DENVER NEPHROLOGY  
1411 S. POTOMAC, SUITE 200  
AURORA, CO

City of Aurora Building Division  
Reviewed for Code Compliance  
Approved as Noted: **Y. Munoz**  
Date: **Mar 25, 2016**  
2015 INTERNATIONAL CODES & 2014 NEC

RSN: 1095504  
Permit #: 16-1076410 LT

## DEMOLITION PLAN

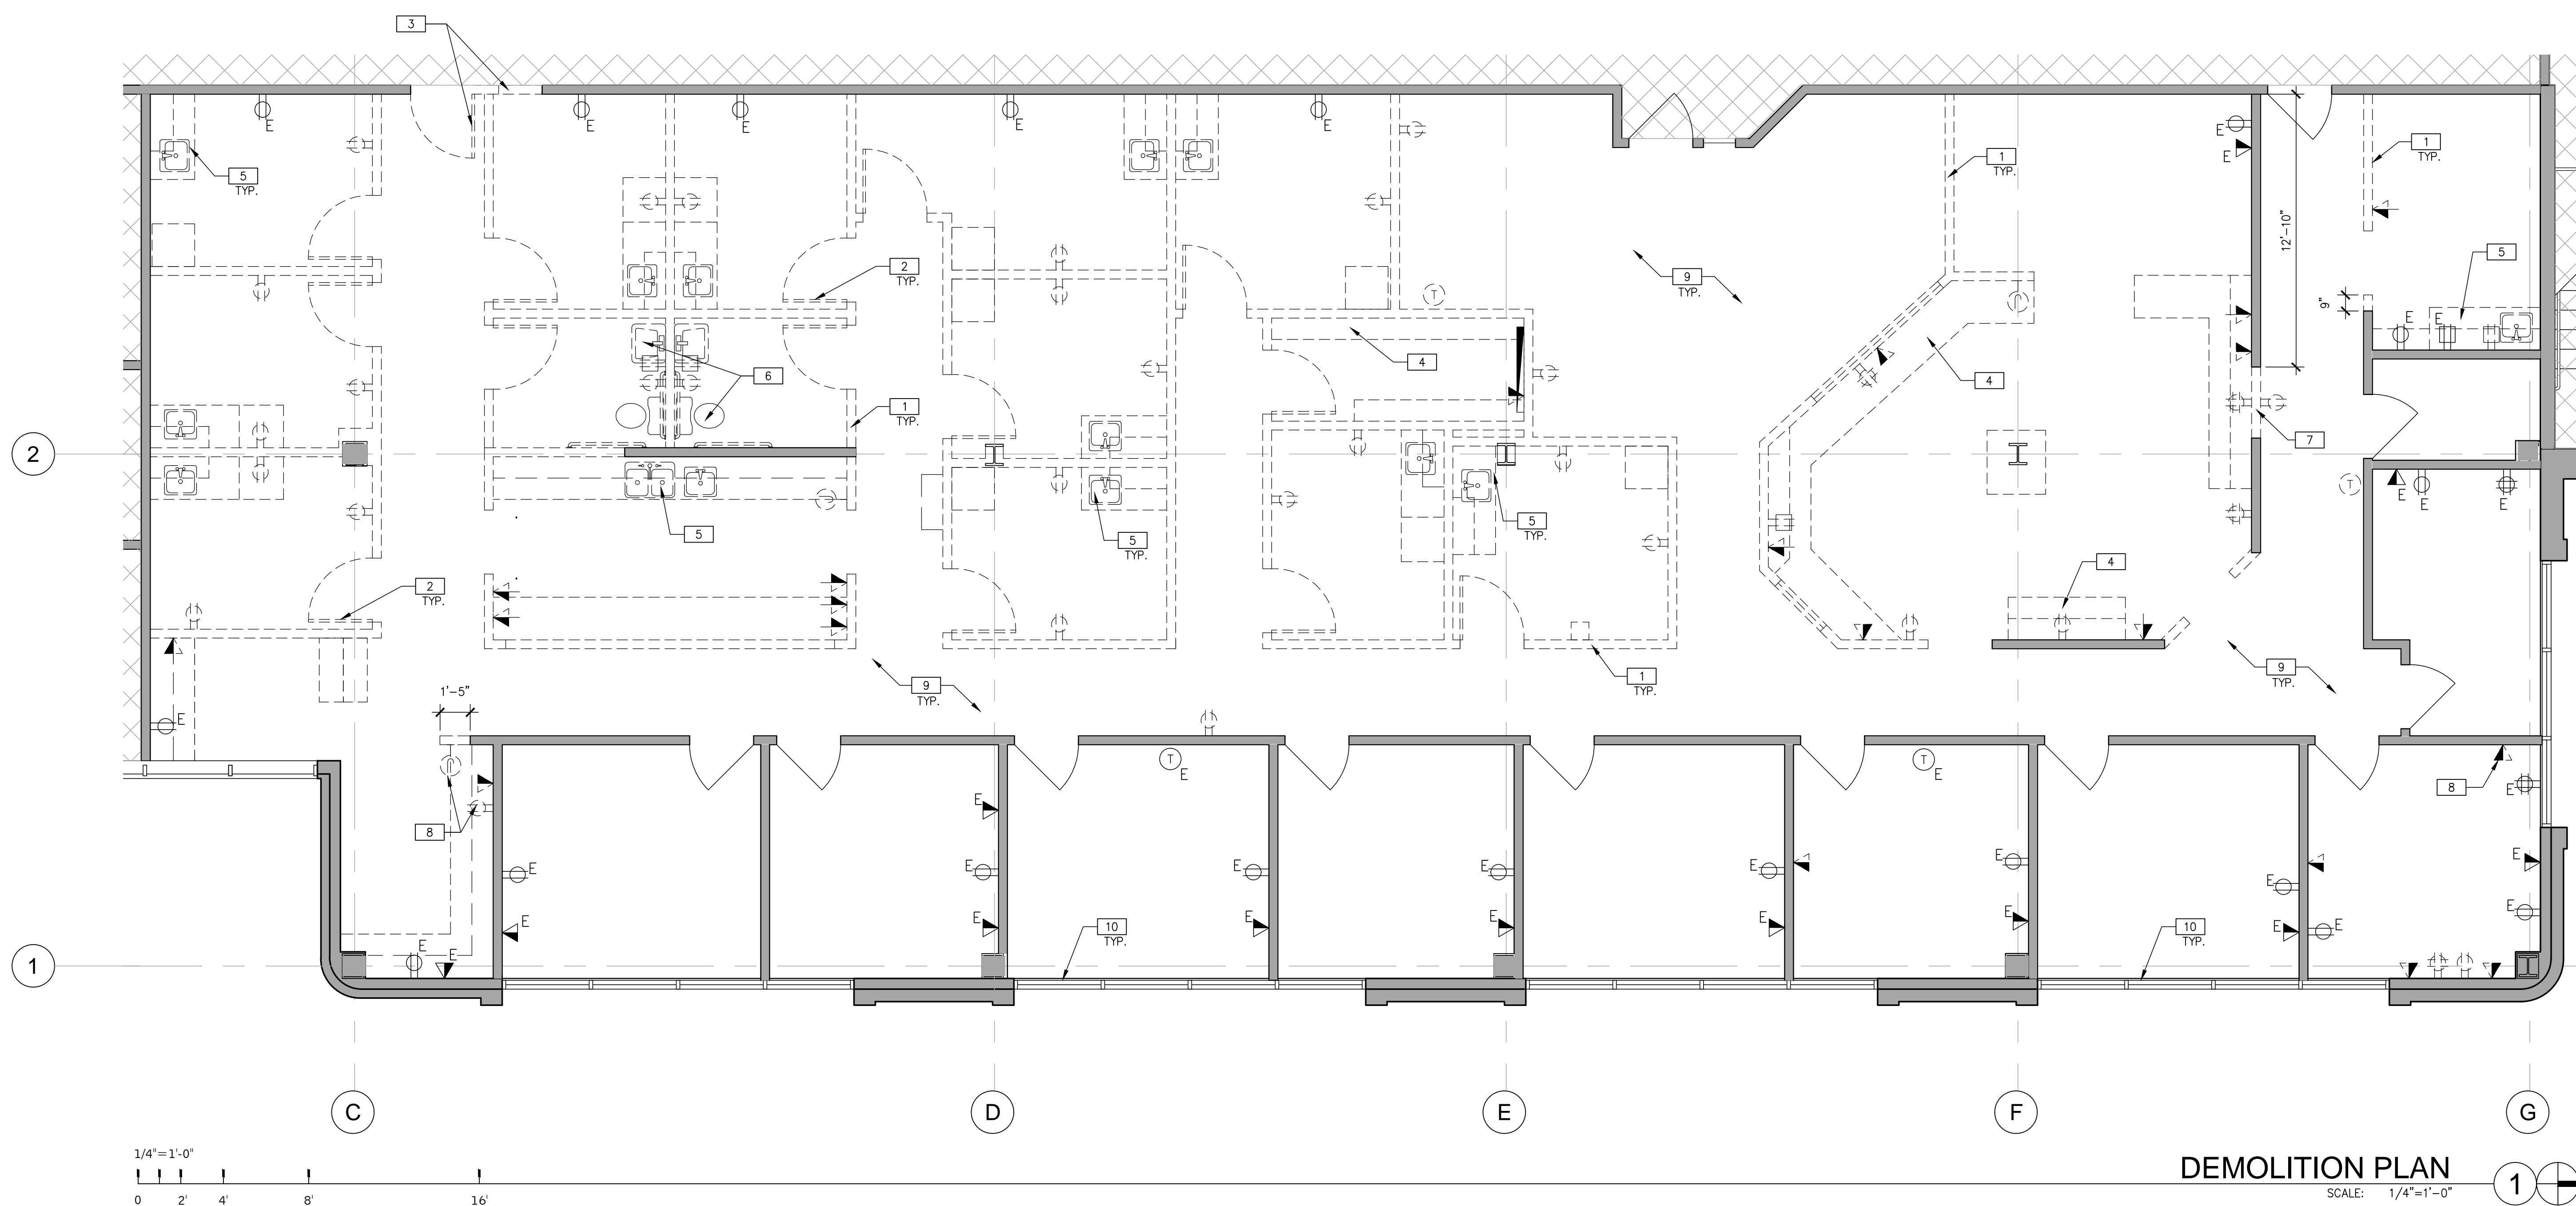
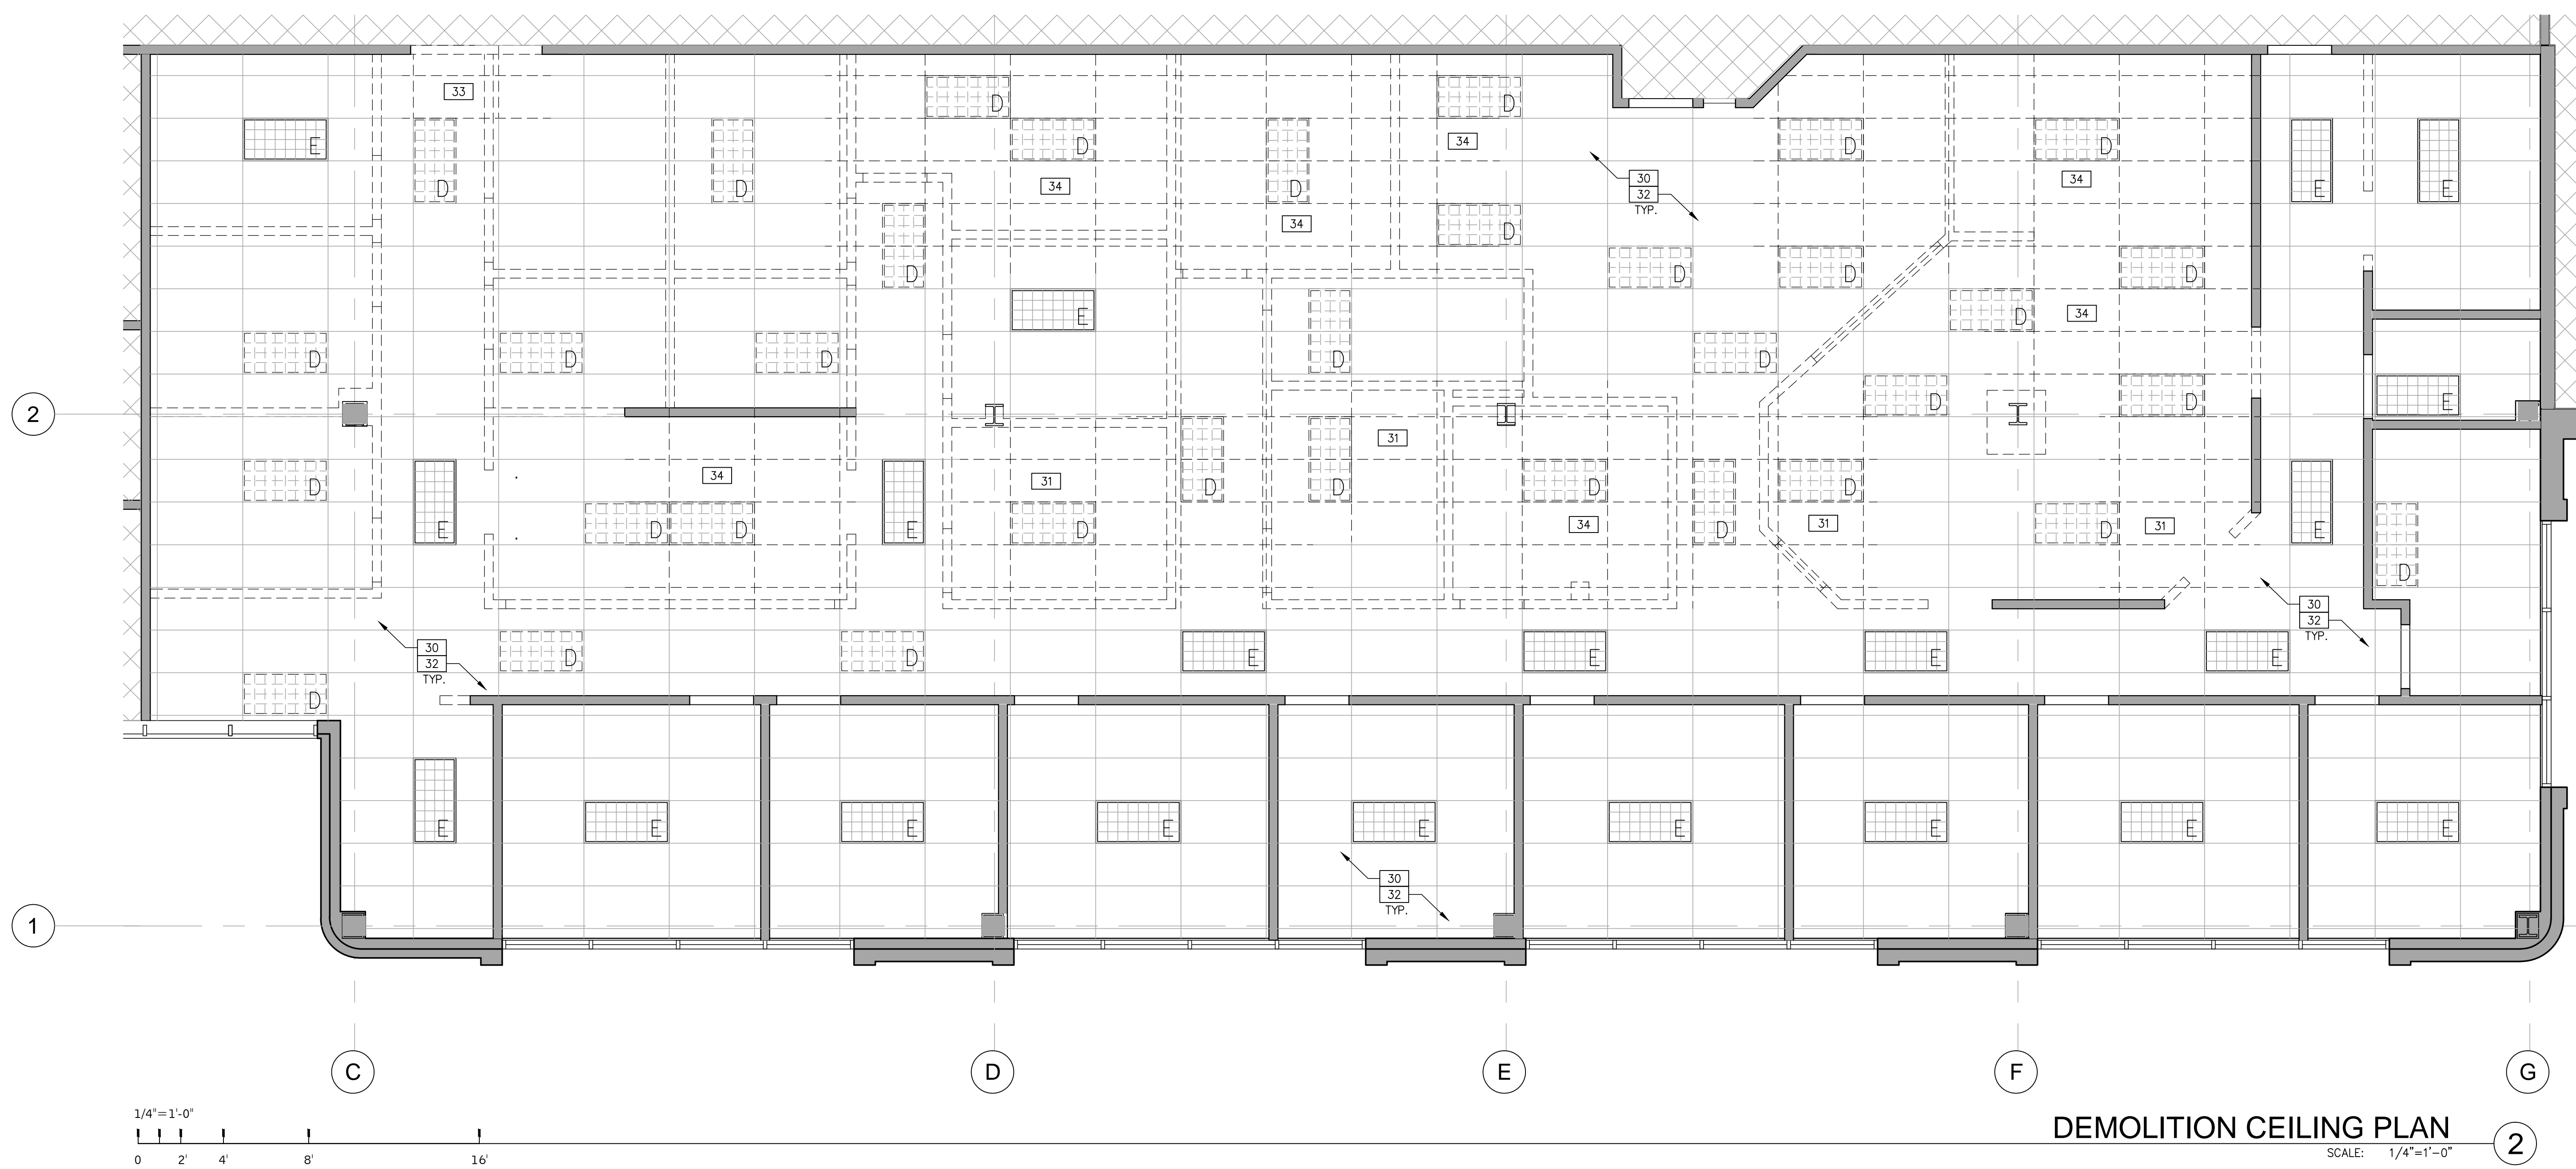
At all times during construction, maintain required exits, existing structural elements, fire protection devices and sanitary safeguards per 2015 IBC 3302.1

PARTITION PLAN  
SCALE: 1/4"=1'-0"

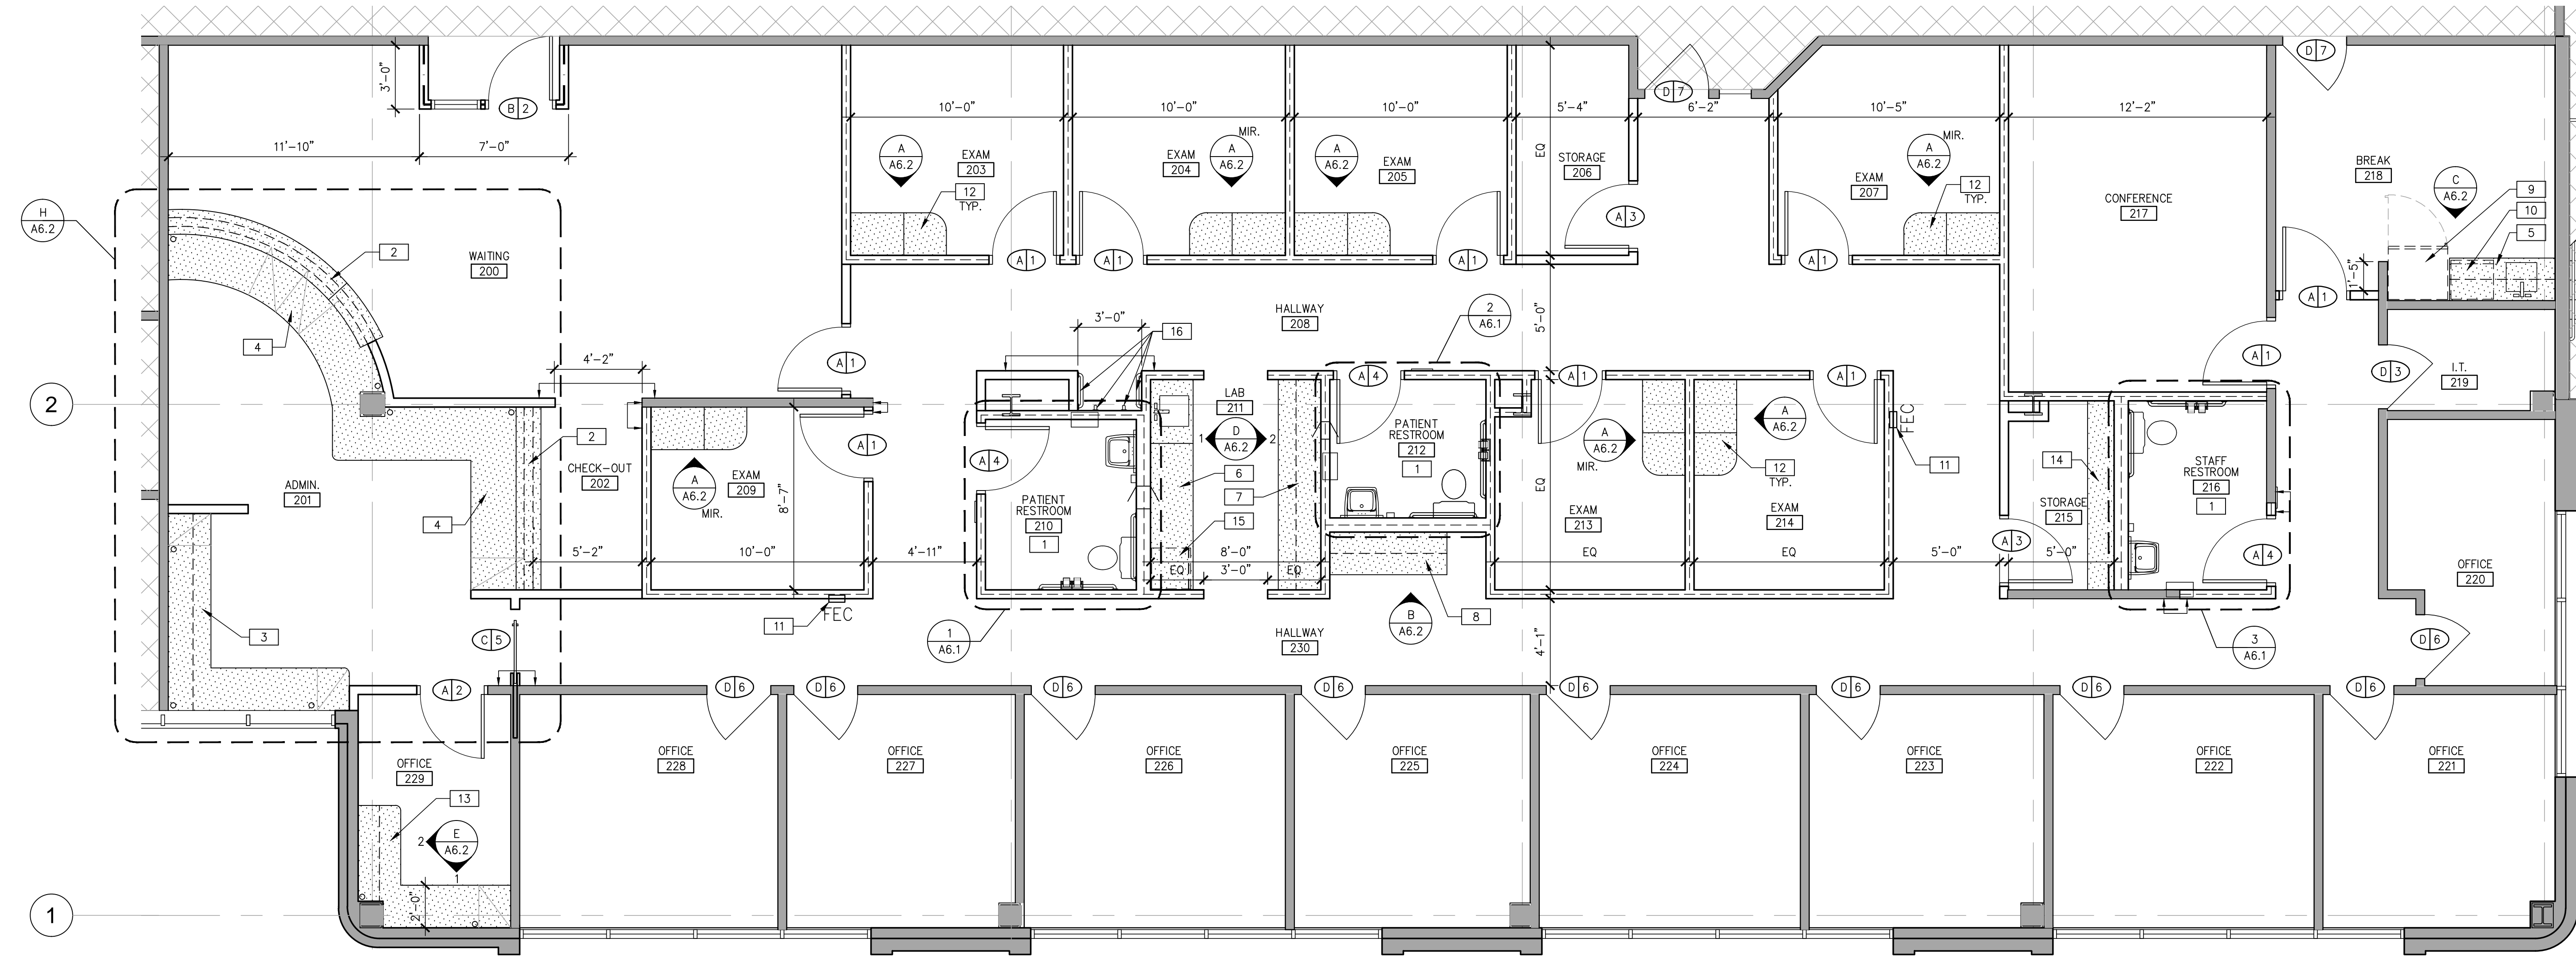
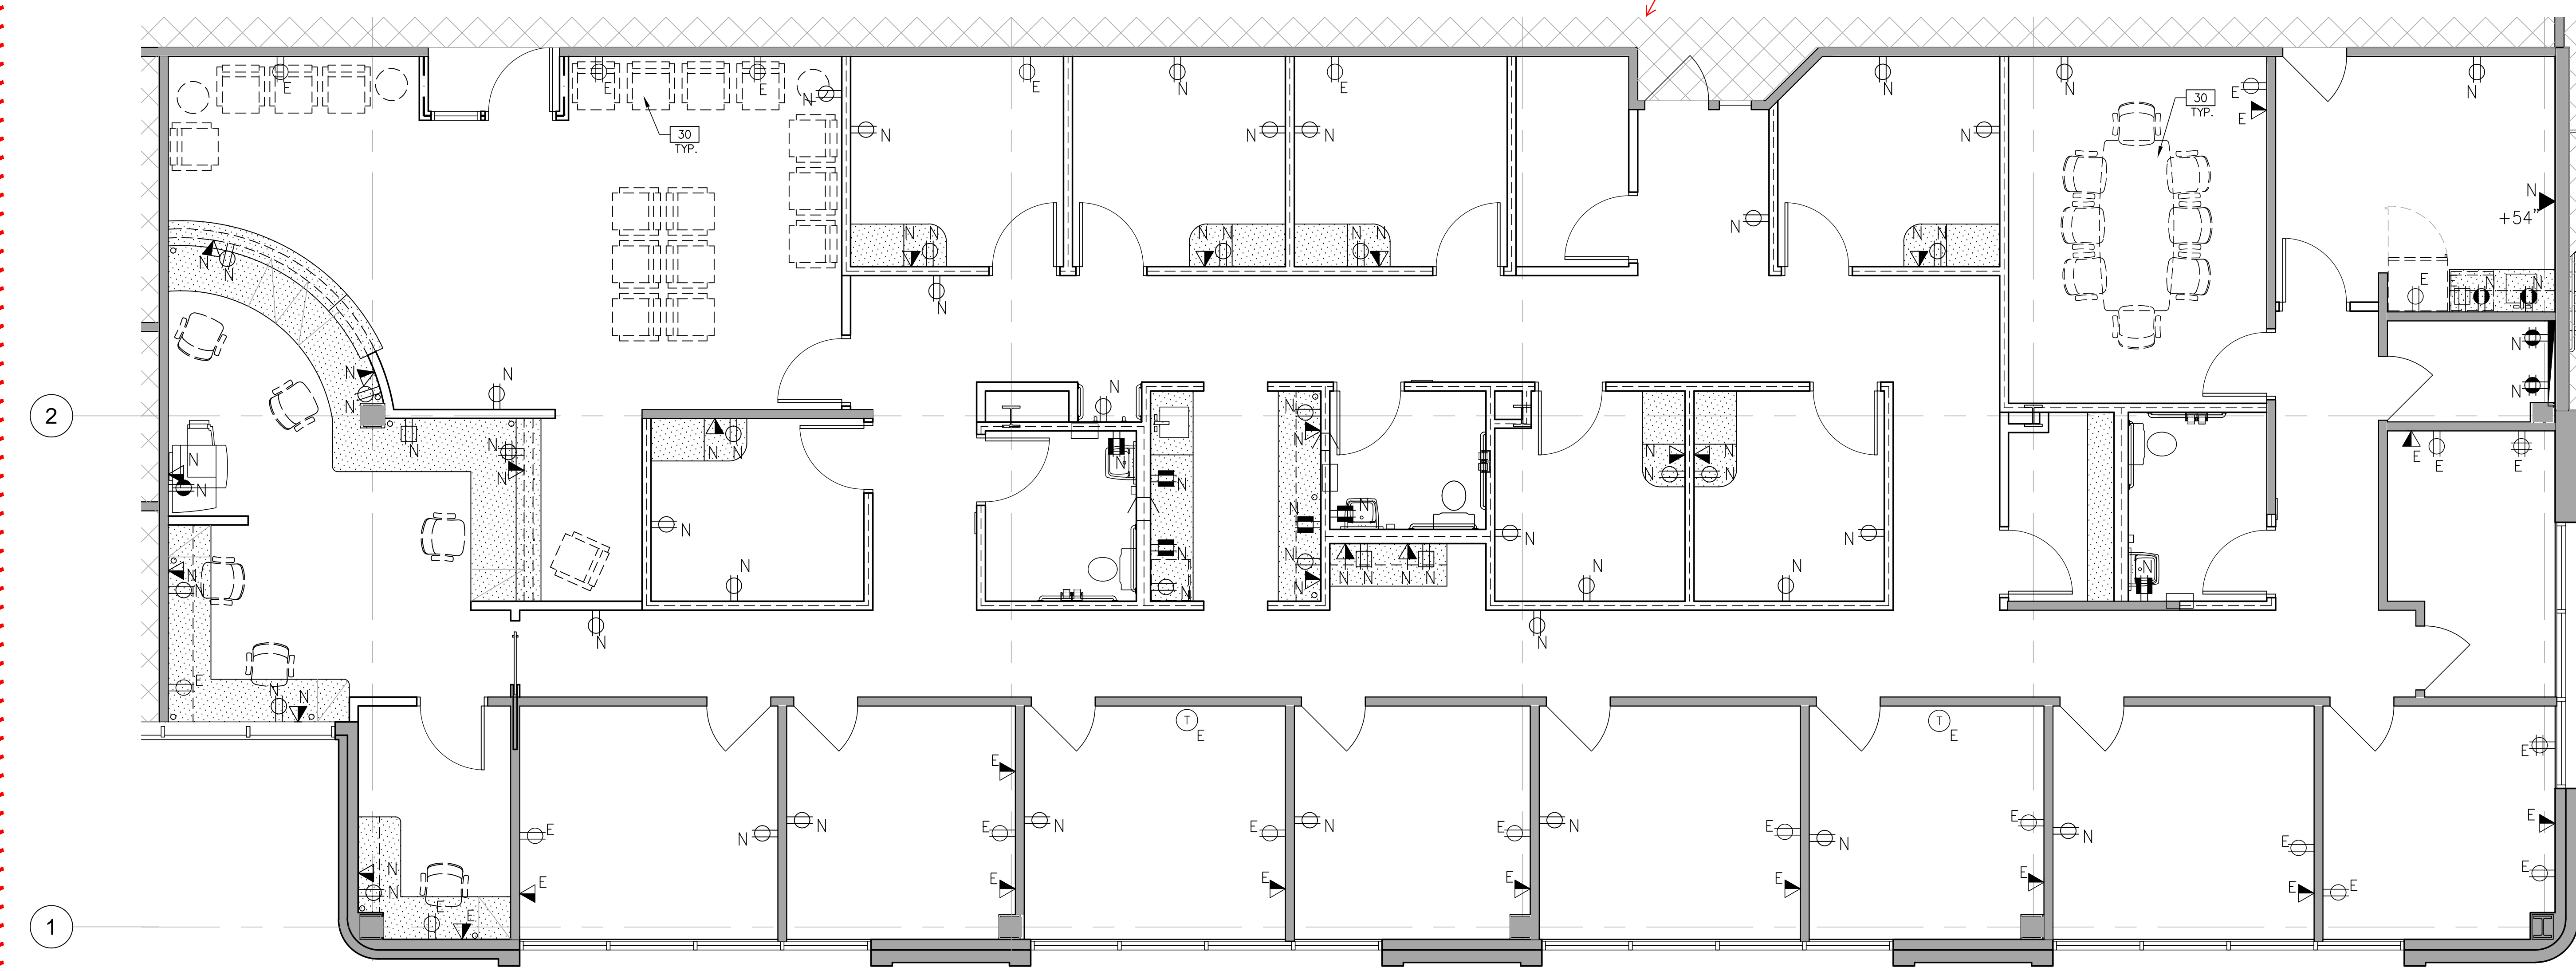
Provide lever or other approved hardware on all new or relocated doors.  
2009 ANSI A117.1

CLOUDED AREA NOT PART OF THIS PLAN REVIEW
